Groundwater Application Review Summary Form

Application # G- 19204

PUBLIC INTEREST REVIEW FOR GROUNDWATER APPLICATIONS

TO: Water Rights Section Date 3/14/2023
 FROM: Groundwater Section Stacey Garrison/Travis Brown
 Reviewer's Name
 SUBJECT: Application G- 19204 Supersedes review of _____
 Date of Review(s) _____

Well 5

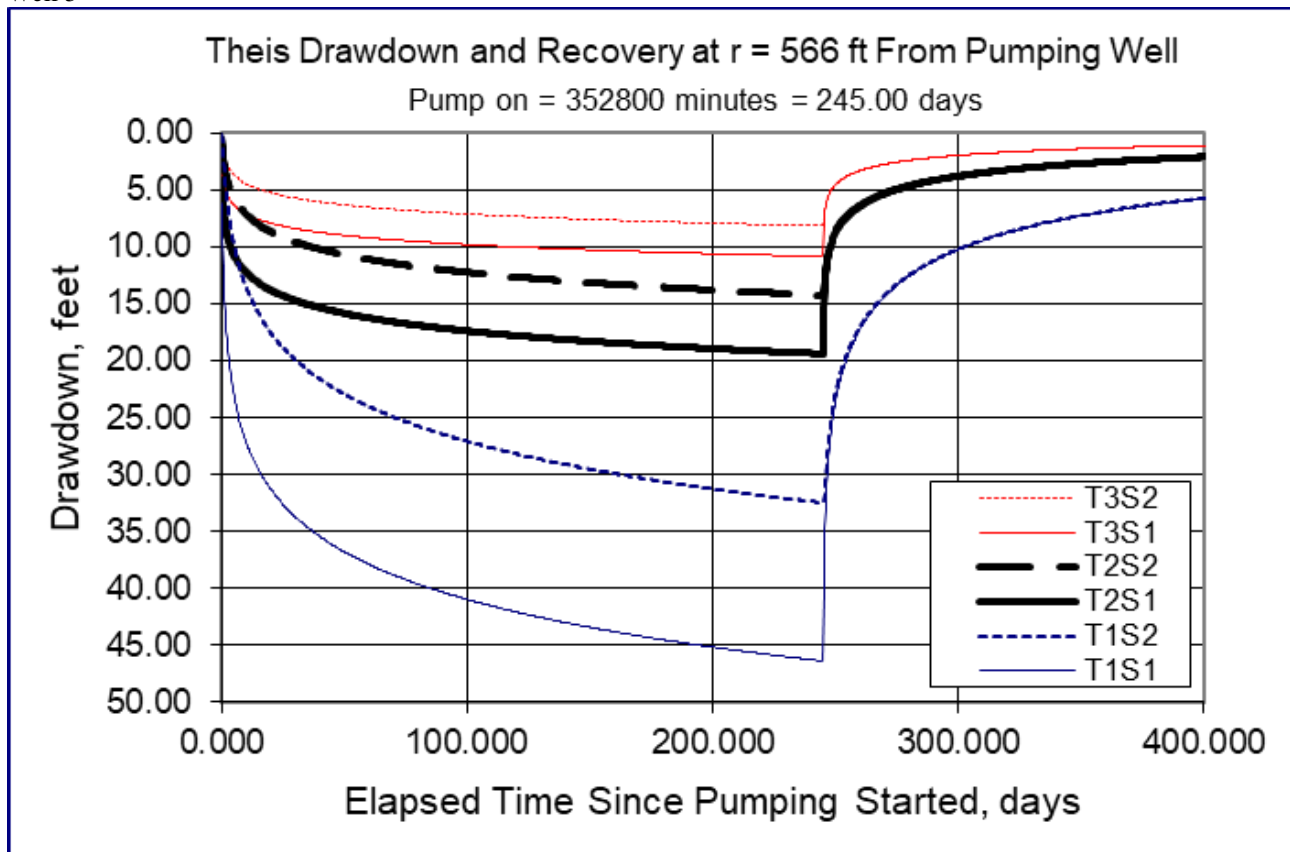
The nearest groundwater user to Well 5 is CLAC 10256 (an exempt domestic well), 566 ft south of the POA at an elevation of ~419 ft msl. CLAC 10256 is drilled to 94 ft bls [325 ft msl] with a WBZ from 85 to 94 ft bls [325 to 334 ft msl], and a seal depth of 50 ft bls [369 ft msl]. It is likely the proposed use would cause some degree of well-to-well interference with CLAC 10256. To assess the degree of drawdown, a Theis drawdown analysis was conducted for the proposed use (see attached **Theis Drawdown Analysis-Well 5**). Results indicate that the proposed use is not likely to cause well-to-well interference with CLAC 20145 that exceeds the threshold under the standard condition for alluvial aquifers in the Willamette Basin.

Based on this analysis of the available data and under the assumptions previously identified, groundwater for the proposed use is likely available within capacity of the resource; if a permit is issued for this application, the conditions in B1(d)(i) and B2(c) are recommended to protect senior users and the groundwater resource.
